Re: Broadway and McKnight Apartments/ 300 McNight Ave. NE

Request for Certificate of Occupancy

Transportation Development Final Inspection Engineer's Stamp dated 12-07-2020 (H14-D112)

TRAFFIC CERTIFICATION

SHEET NUMBER SP-DRB

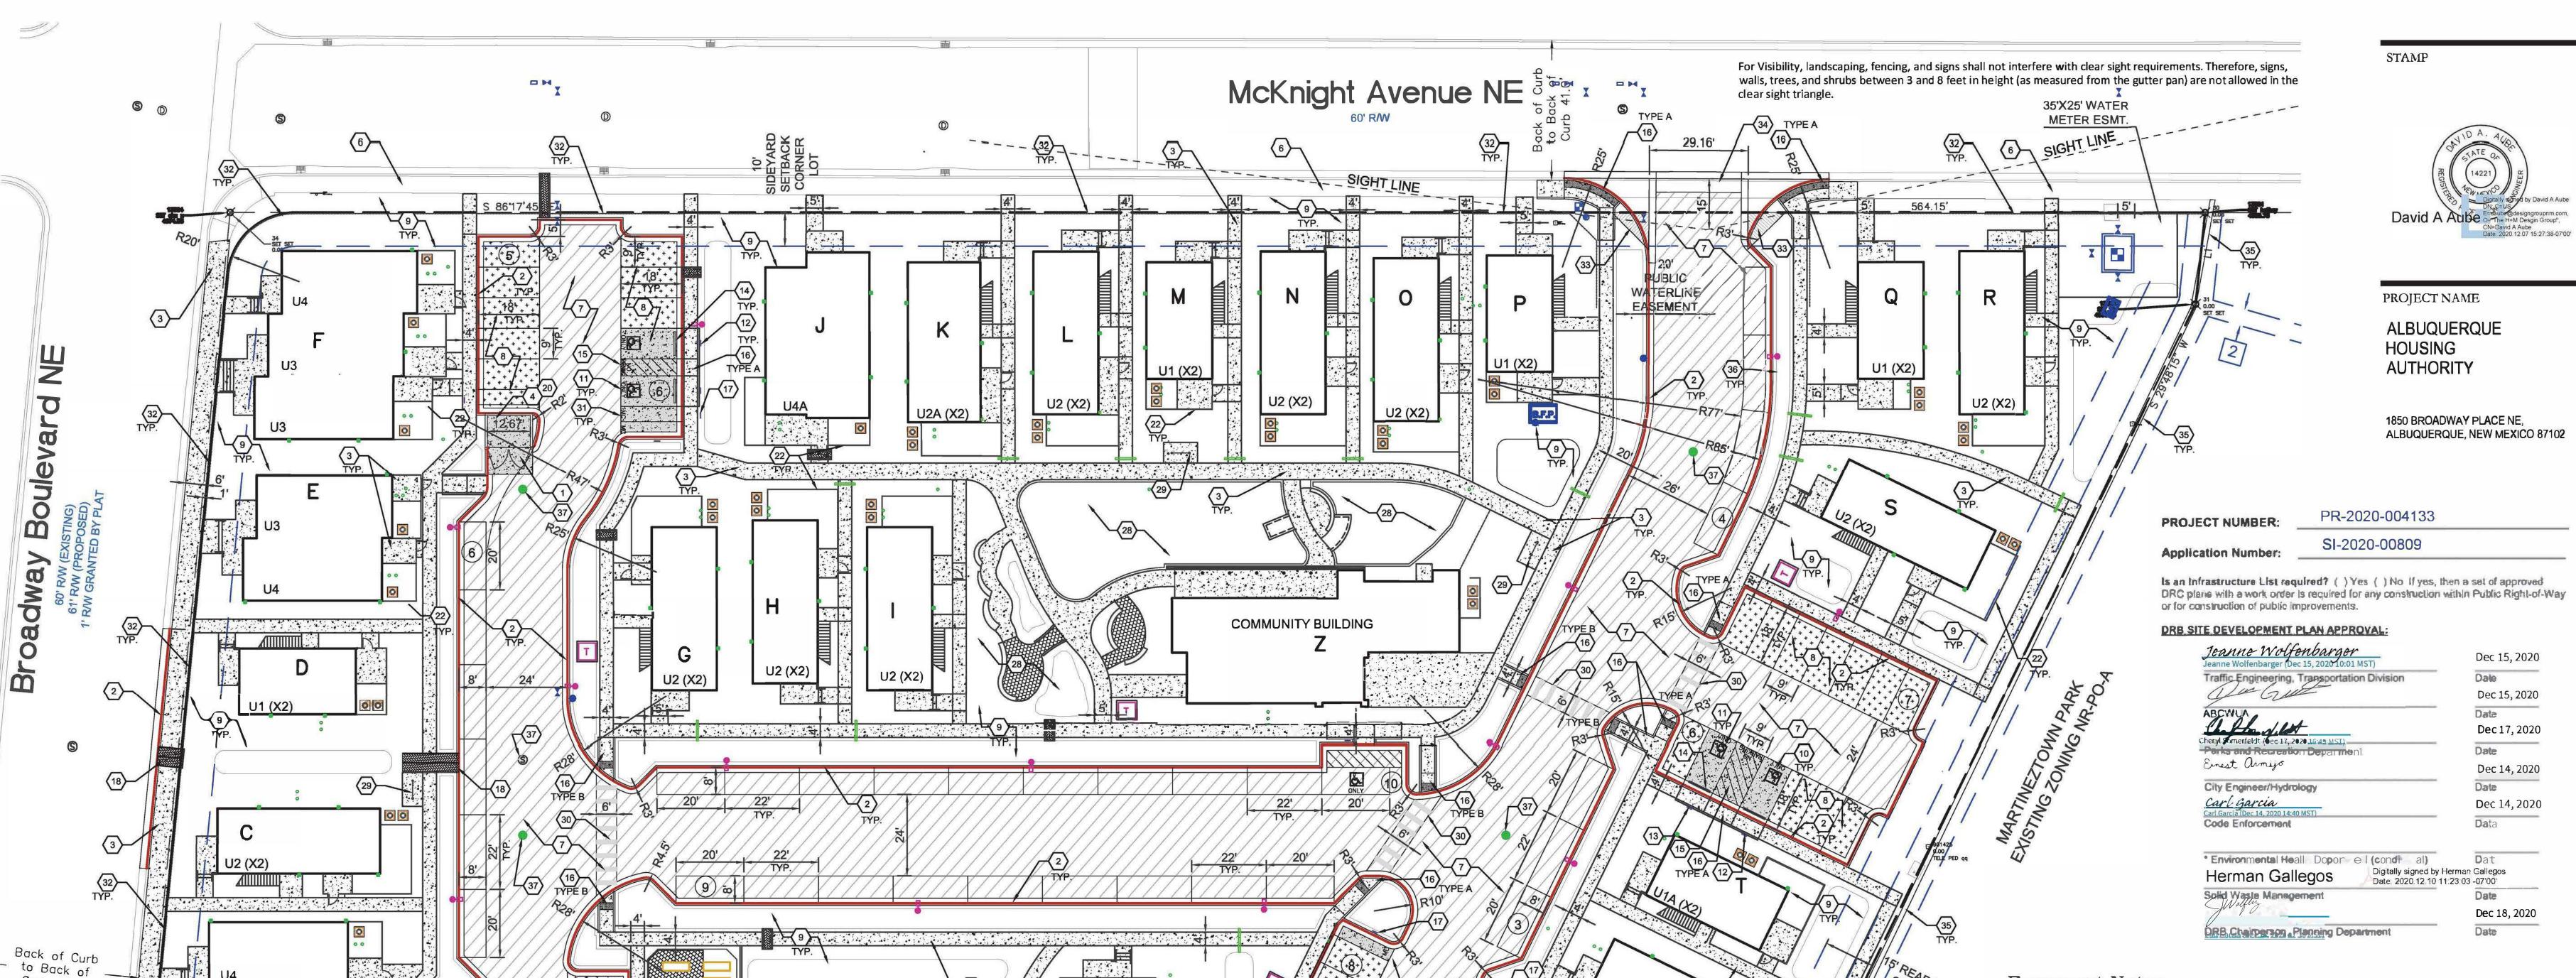
REVSIED TO GARVEL PAVED (AS-BUILT CONDITION) ——
